S16YW

Subject: S16YW
Side Emergency Door Heater Pipe

Models Affected: Model Year: Certain 2016-2017
Model: Vision and All American

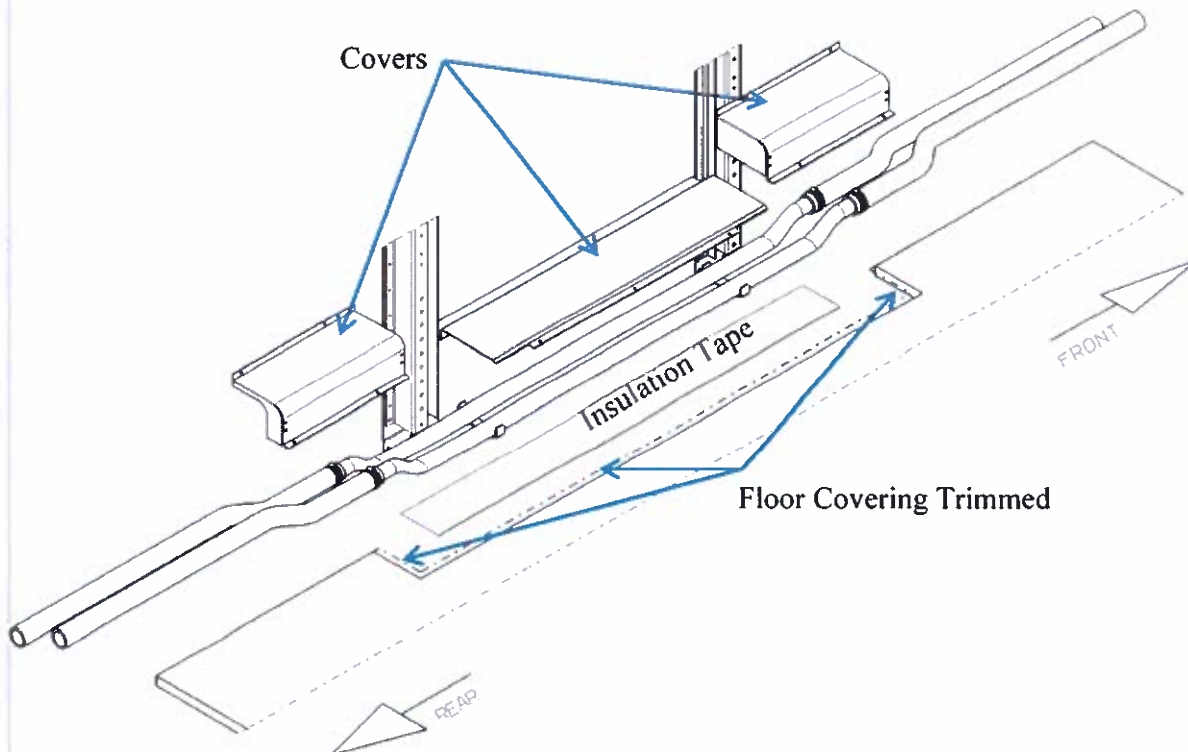
Side Emergency Door heater piping may not be installed properly. Floor covering material may not be trimmed properly forcing heater pipe to be too high.

Inspect for proper installation. Trim rubber floor covering, if needed.

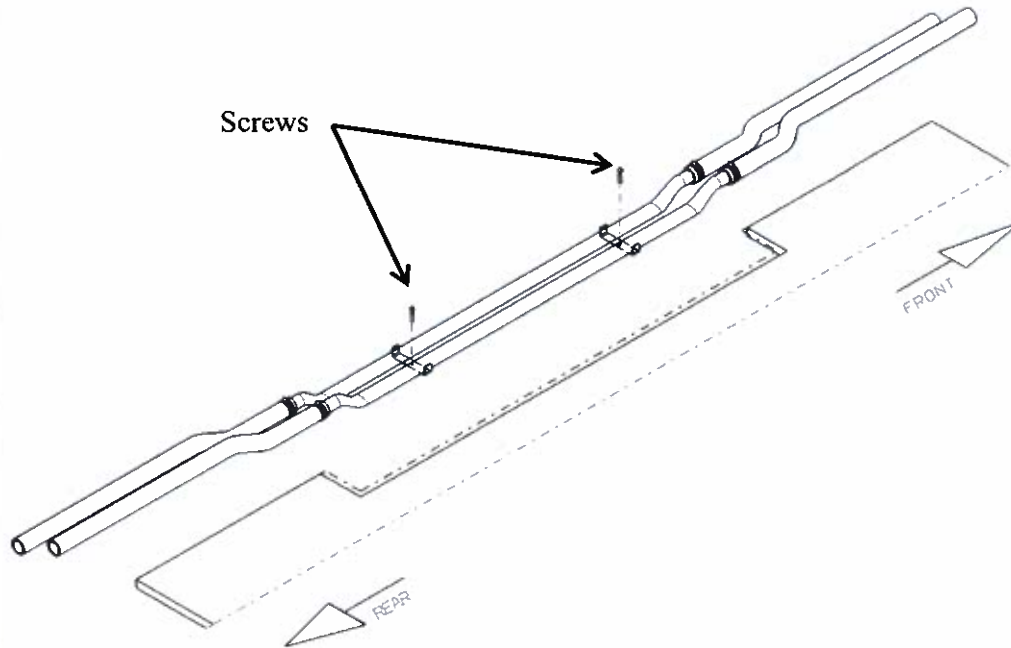
3. Inspect rubber floor covering at notched plywood.
4. Floor covering should be trimmed to overlap plywood by .375 of an inch.
5. It should NOT extend under the heater pipes.
6. If rubber floor mat is trimmed properly, re-install covers.

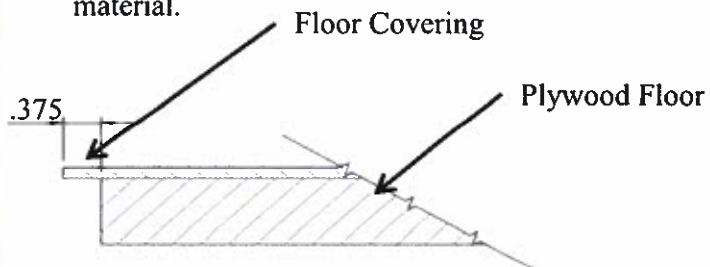
7. If floor mat is not trimmed, remove the two screws securing heater pipes to floor (do not remove hose clamps).

8. Raise the heater pipes to provide access to trim floor covering.
9. Trim the floor covering to overlap plywood by .375 and discard excess floor covering material.
